Hungry Horse - Columbia Falls Line Rebuild

RESPONSE TO COMMENTS ON DRAFT EIS  
Department of the Army Corps of Engineers (Omaha)  
Richard D. Gorton, Chief, Environmental Analysis Branch  
Planning Division (9/2/92)

RESPONSE TO MDT FOLLOW-UP LETTER CONTAINING  
RESPONSES TO AGENCY COMMENTS ON DRAFT EIS

DESIGN SPECIFICATION #2  
SLOPE STABILIZATION/BANK EROSION CONTROL/FISH HABITAT

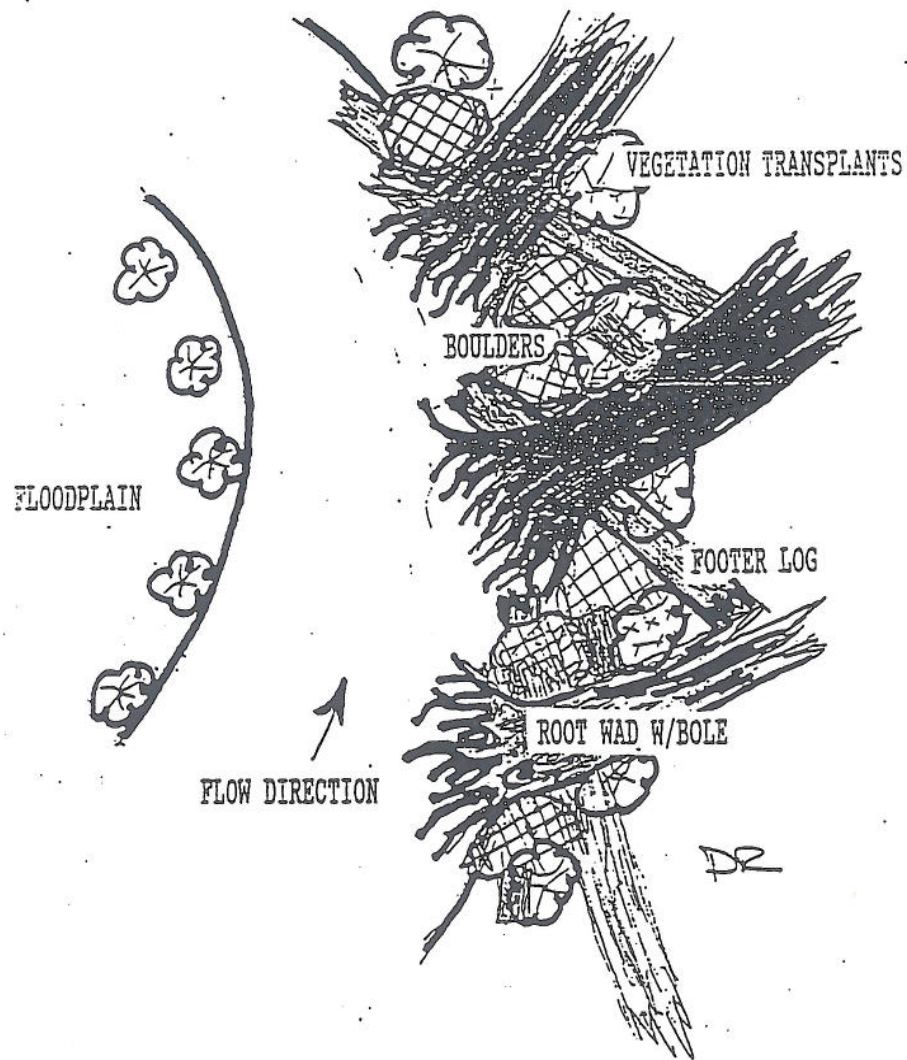
The EPA would recommend a more innovative means of riverbank protection than standard rock riprap. The placement of logs, root wads, and vegetative plantings should be intermixed with rock placement along the South Fork of the Flathead River to stabilize riverbanks where encroachment occurs. The logs, root wads, and vegetative plantings provide a more natural appearance to the bank stabilization, and also provide additional habitat value (shading and cover). The enclosed diagrams provide an example of this type of stabilization.

7. **RESPONSE:** The incorporation of alternative riverbank protection measures into the design of the proposed action was discussed at meetings with the EPA held during December, 1992 and April, 1993. As the result of the most recent meeting with Steve Potts, Environmental Coordinator for the EPA's Montana Office, it was understood that reducing the proposed encroachment on the Flathead River was preferable to incorporating the riverbank stabilization measures recommended by EPA into the design of the fill area proposed in the Draft EIS.
